Errata Sheet

Product Family: DL205

Manual Number D2-USER-M

Revision and Date 4th Edition, Rev. B; February 2013

Page 4-28. Expanding DL205 I/O; Configuring the CPU's Remote I/O Channel

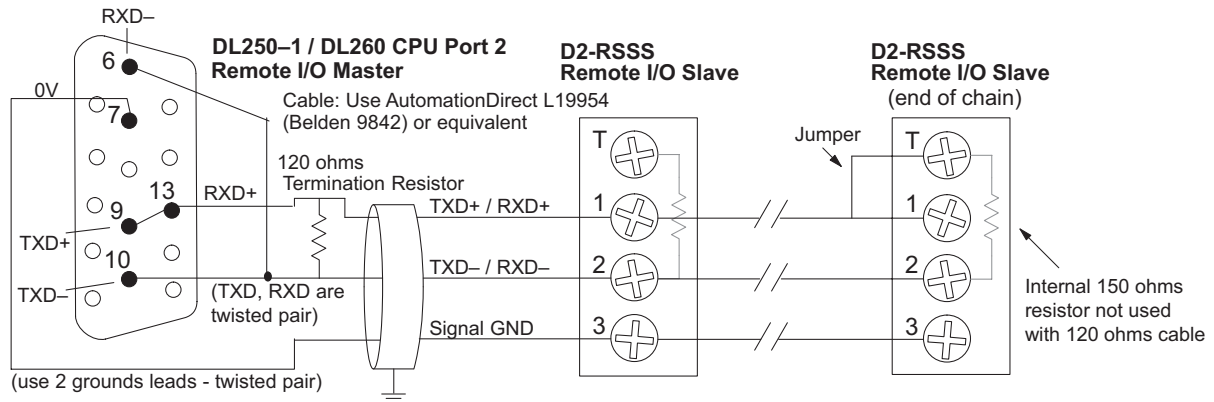
Replace the wiring drawing shown with this one:

Replace the paragraph right after this wiring drawing with this paragraph:

The twisted/shielded pair connects to the DL250-1 or DL260 Port 2 as shown. A termination resistor must be added externally to the CPU, as close as possible to the connector pins. Its purpose is to minimize electrical reflections that occur over long cables. A termination resistor must be present at both physical ends of the network.

Add this Note at the bottom of the page, right after the existing note:

See the transient suppression for inductive loads information in Chapter 2 of this manual for further information on wiring practices.
